February 23, 2015

## **National Park Service General Comments on the Desert Renewable Energy Conservation Plan (DRECP) Draft Environmental Impact Statement (EIS) and Supporting Documents**

National Park Service Comments on the Desert Renewable Energy Conservation Plan Draft Environmental Impact Statement – February 2015

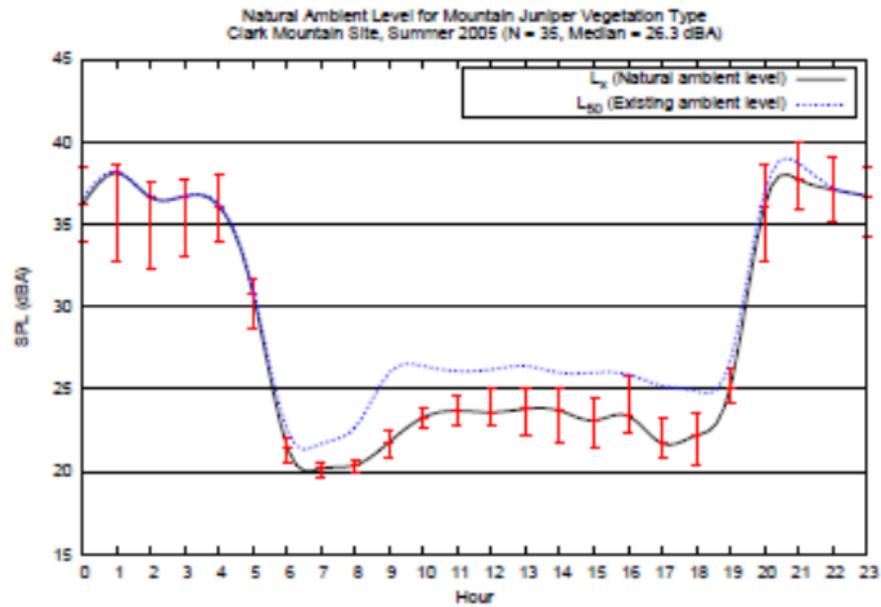
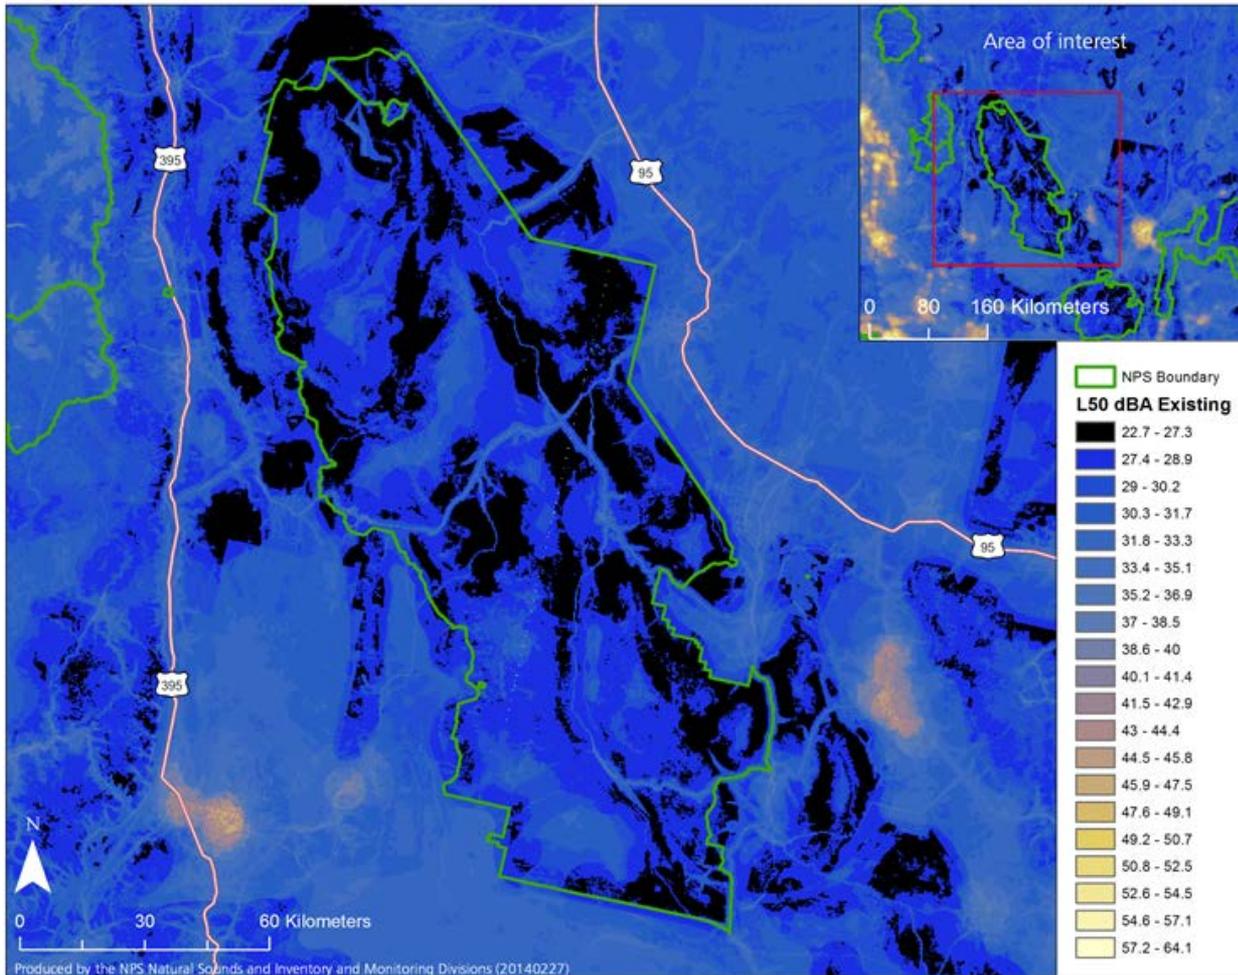
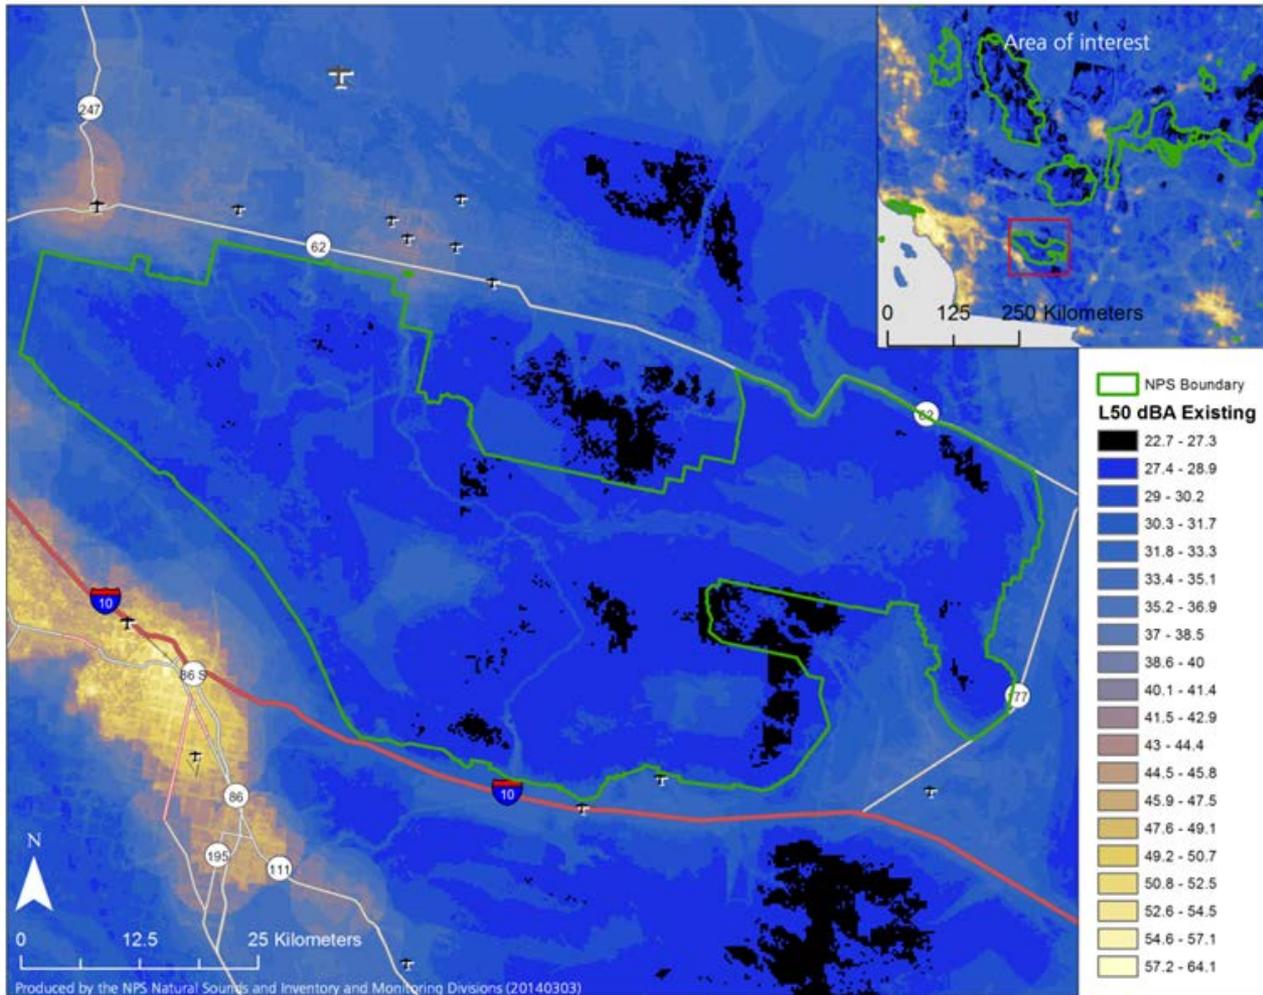
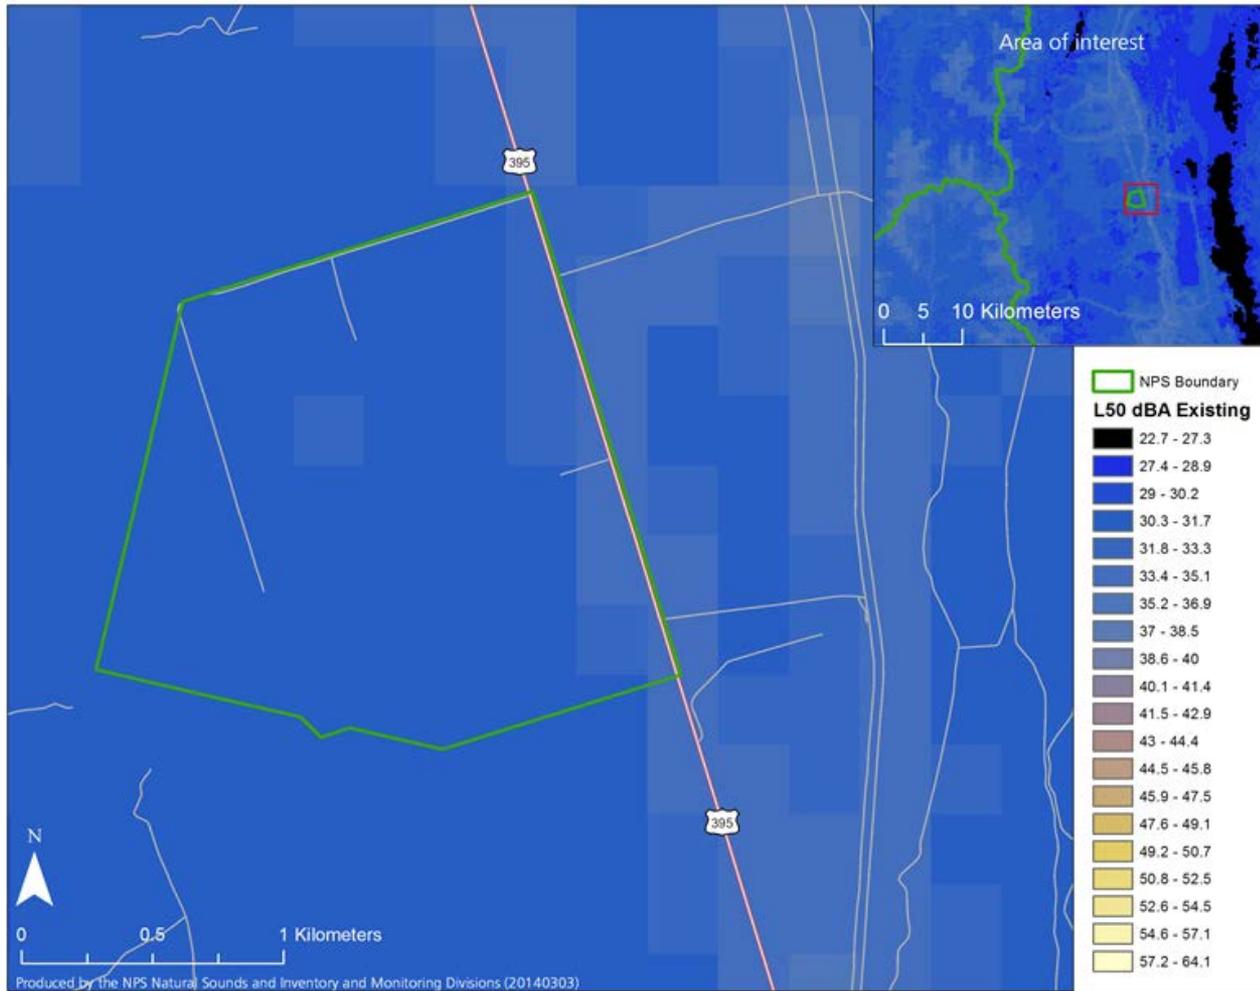
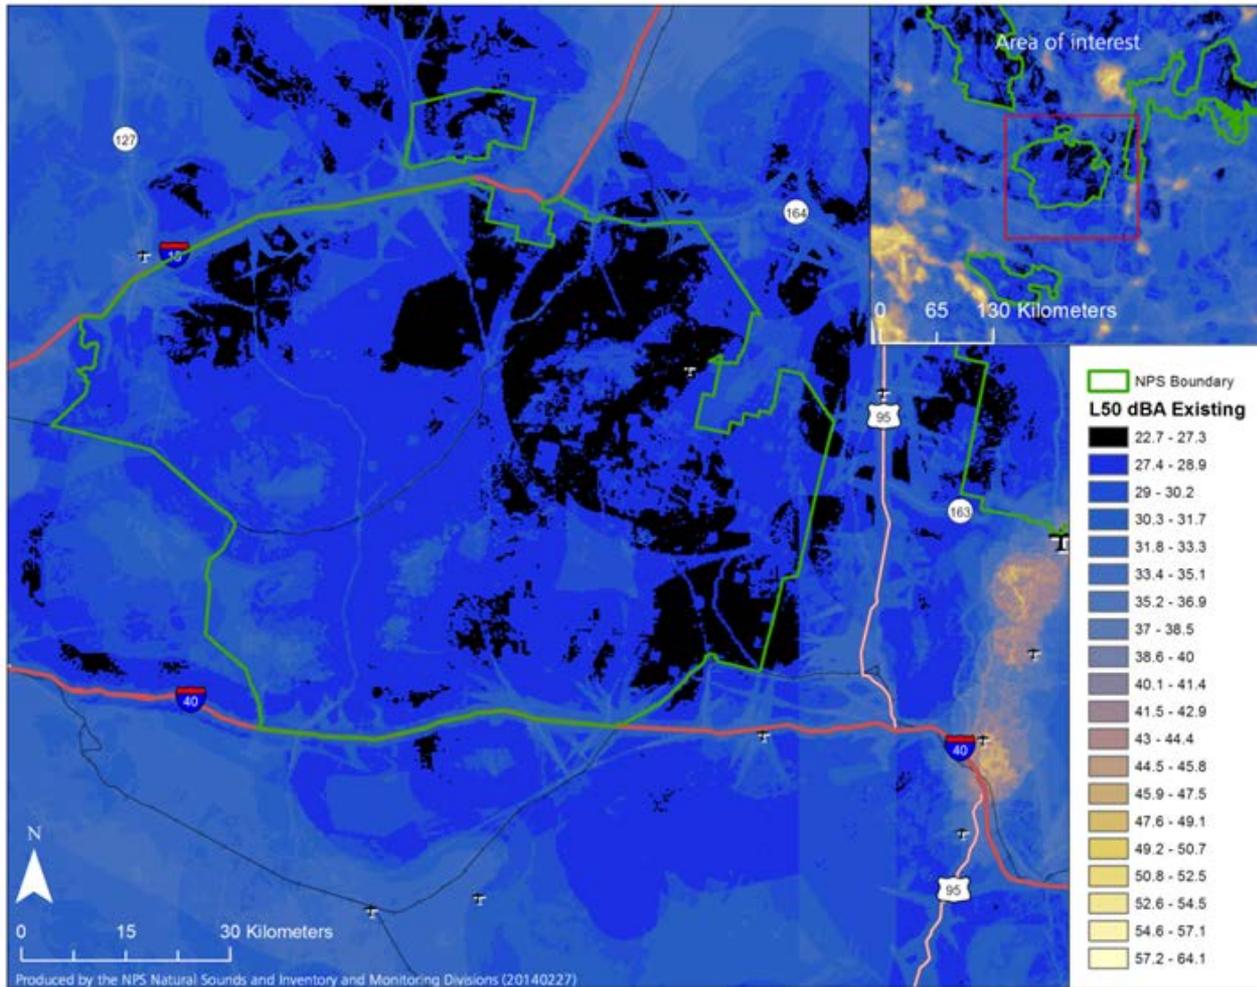
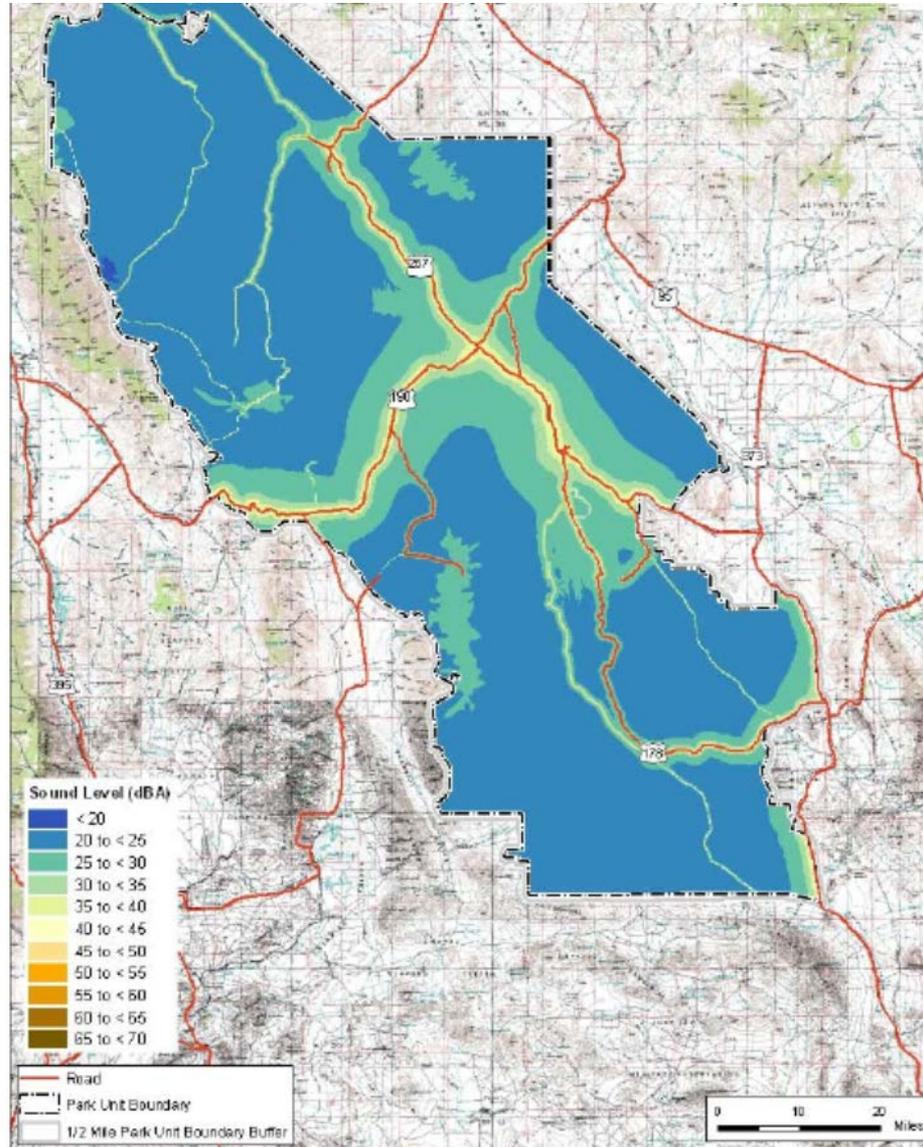
Number	Volume	Chapter	Section	Page	Paragraph	Comment
						<p>The NPS Night Sounds and Natural Skies Division (NSNSD) has conducted acoustical monitoring in several parts of this region. Reports are available for Mojave National Preserve and Death Valley National Park, and can be provided to the REAT agencies or EIS consultants on request. Figures 9 and 10 graphically illustrate some of the results of the studies. In general, sound levels are elevated near human installations such as roadways and towns.</p> <p>In the absence of acoustical measurements, NSNSD uses a geospatial model to predict existing sound levels, natural sound levels, and impacts to the natural sound baseline. Sound pressure levels for the continental United States were predicted using actual acoustical measurements combined with a multitude of explanatory variables such as location, climate, landcover, hydrology, wind speed, and proximity to noise sources (roads, railroads, and airports). The model predicts daytime sound levels during midsummer. Figures 10-13 are images of predicted existing conditions based on the model. Darker colors show quieter conditions.</p>
